ADDENDUM NO. 01

Lewis Central Community School District
Lewis Central High School – Wrestling Wall Removal
Council Bluffs, Iowa 51503
BCDM Project No. 5551-06

March 26, 2026

E1-0

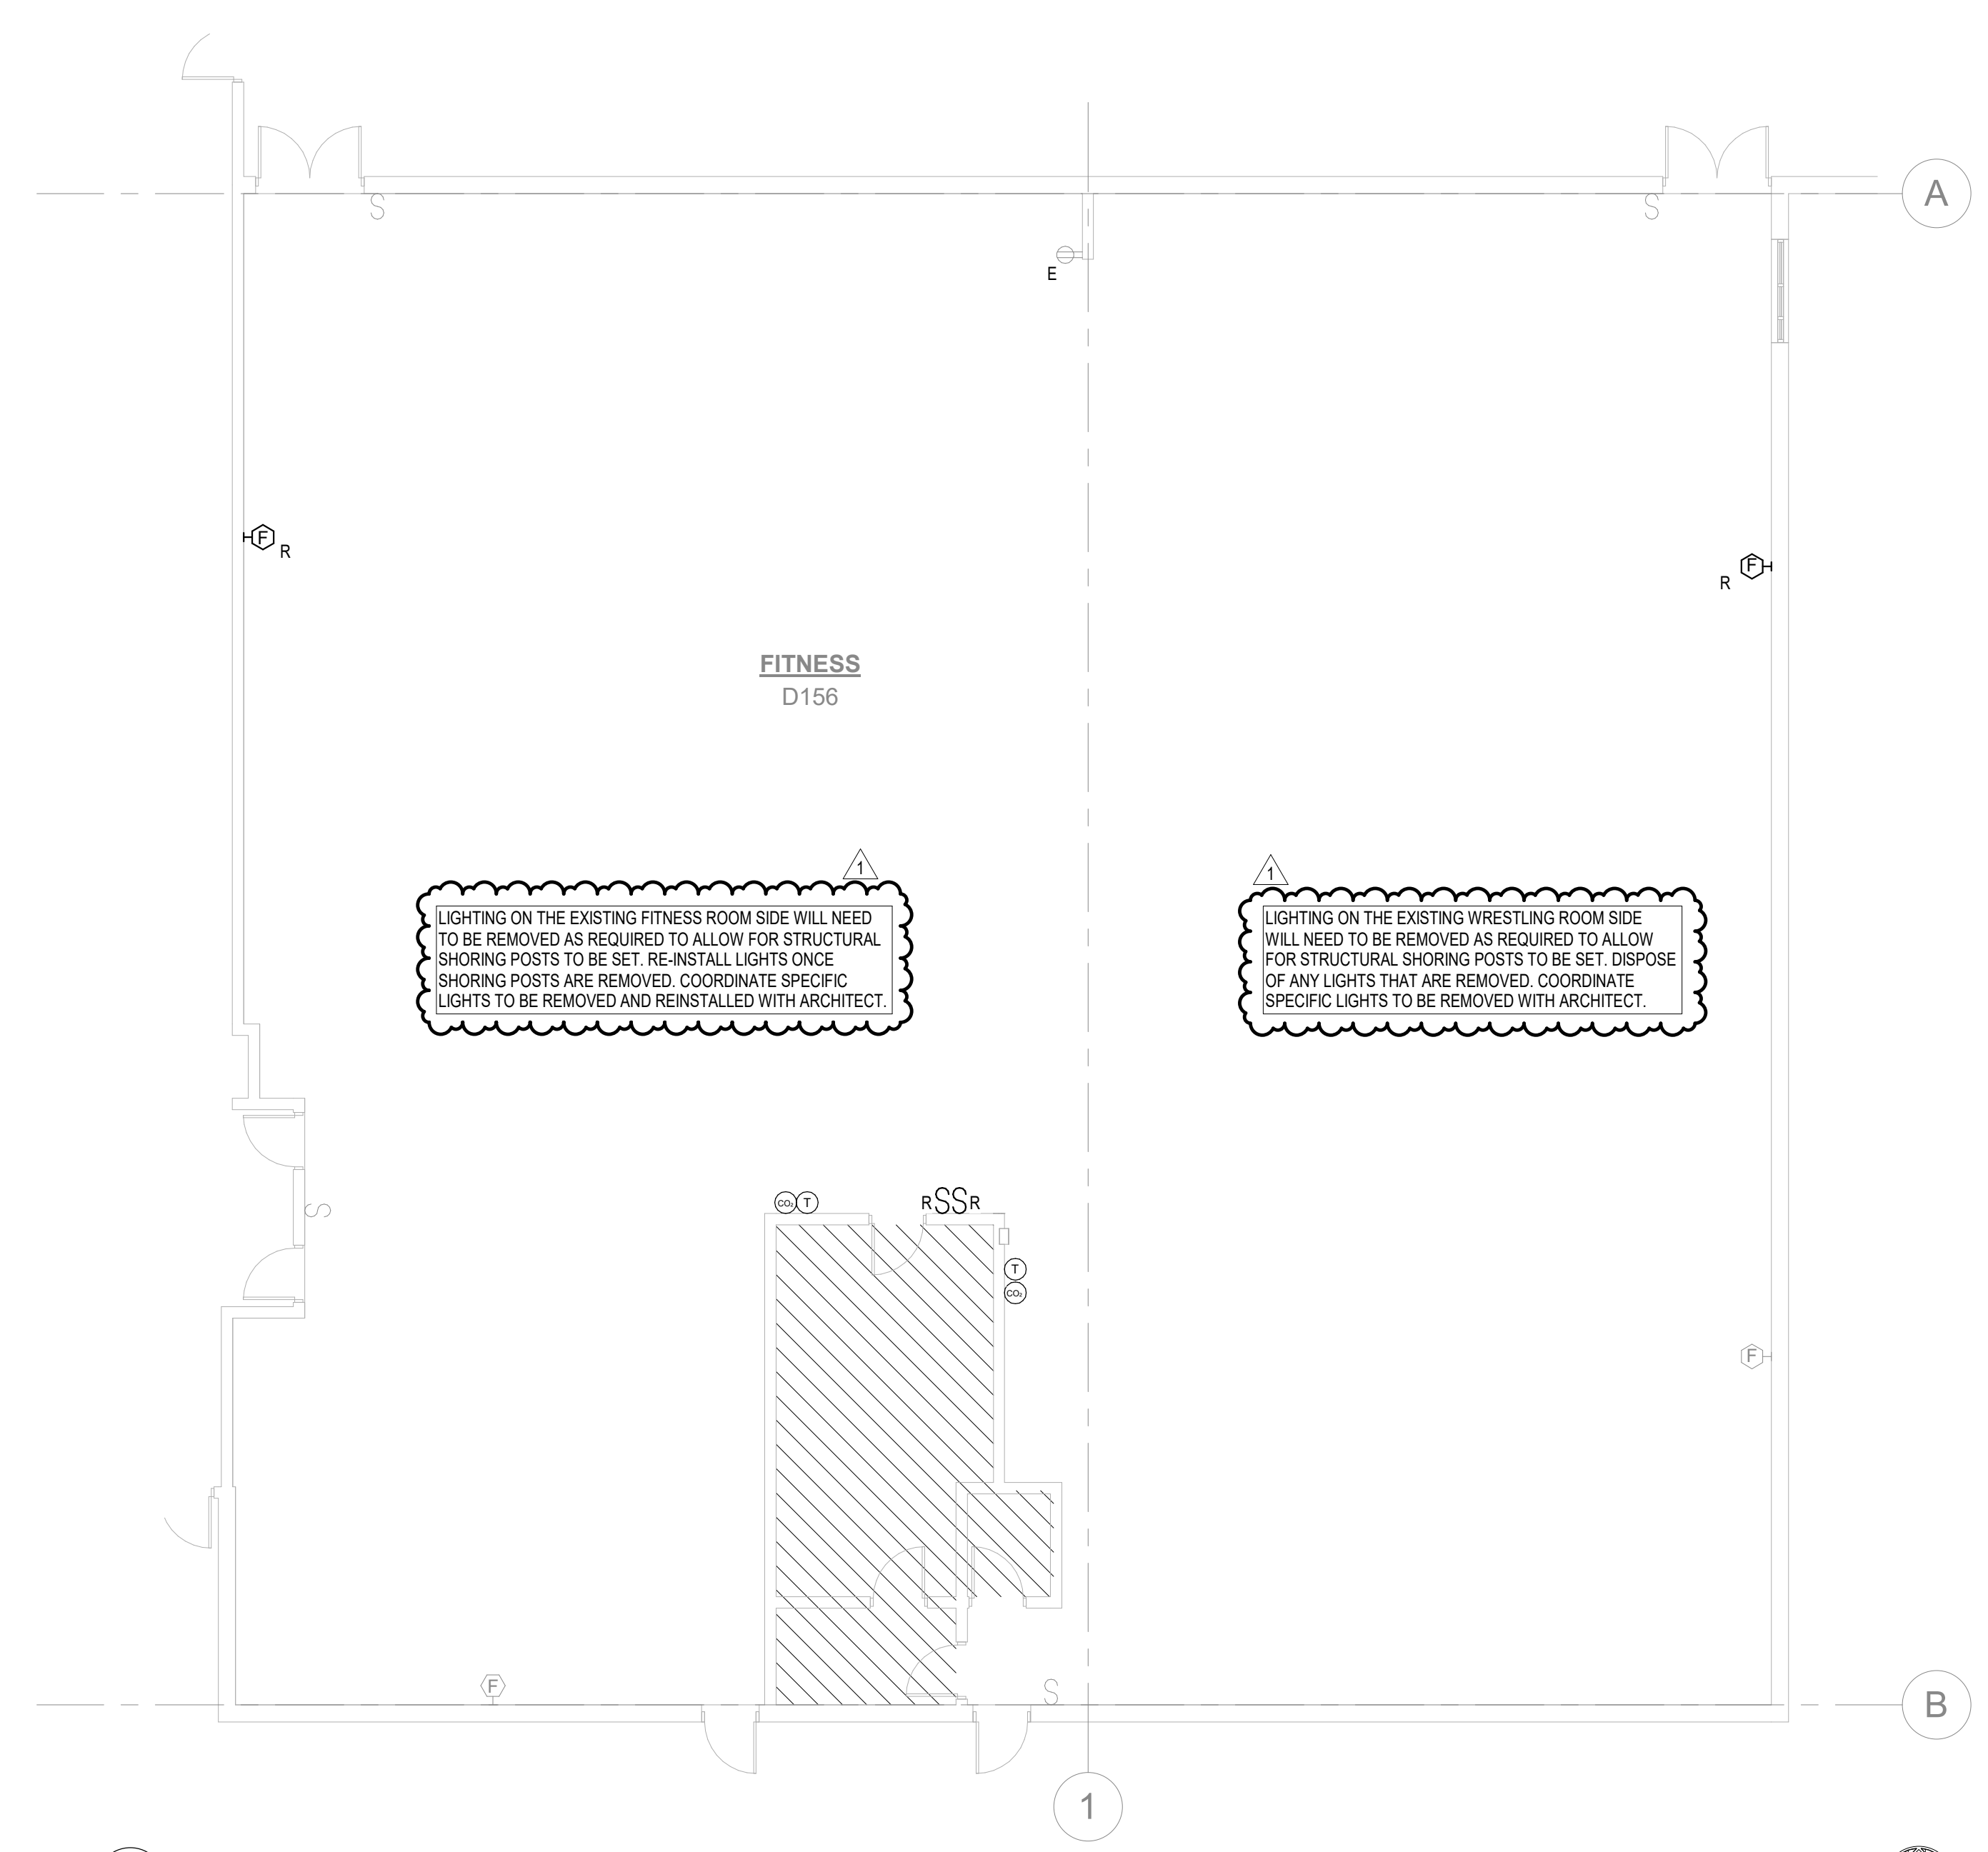
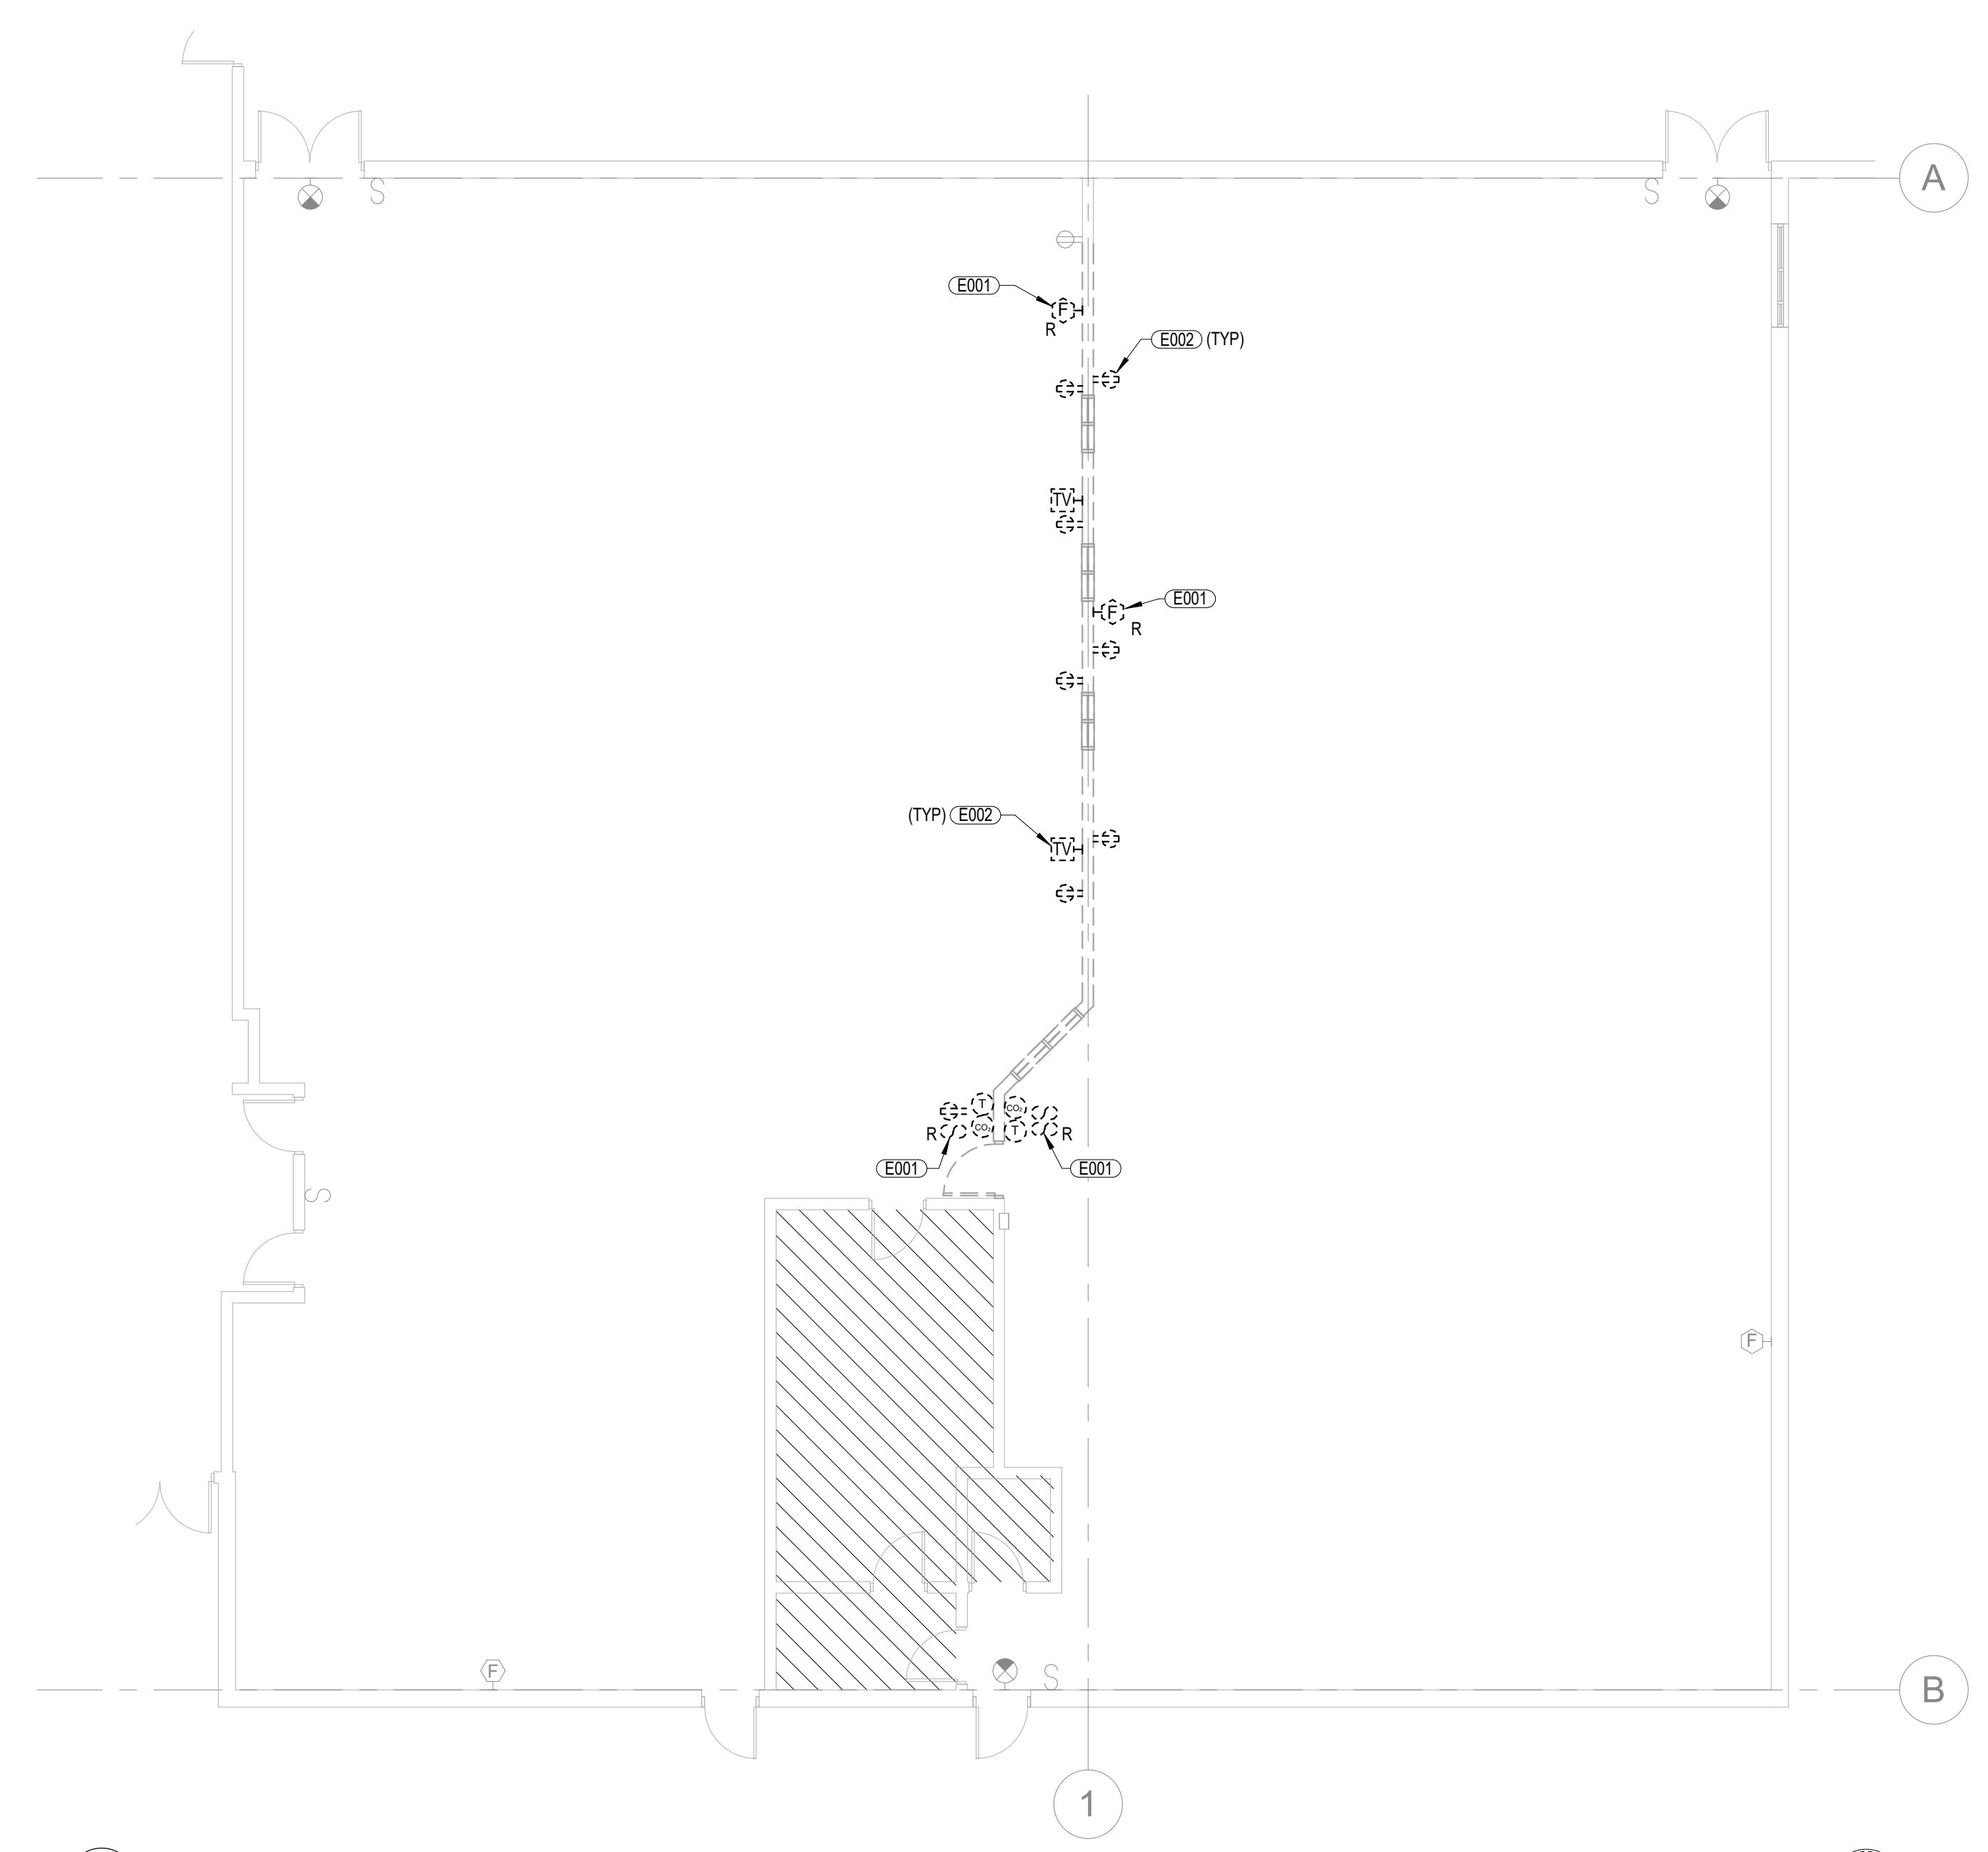
- a. See Morrissey Engineering's Addendum No. 1 drawing attachments.

E001 REMOVE DEVICE AND SET ASIDE FOR RELOCATION. SEE NEW WORK PLANS FOR NEW LOCATION.

E002 REMOVE DEVICE AND ALL WIRING BACK TO SOURCE.
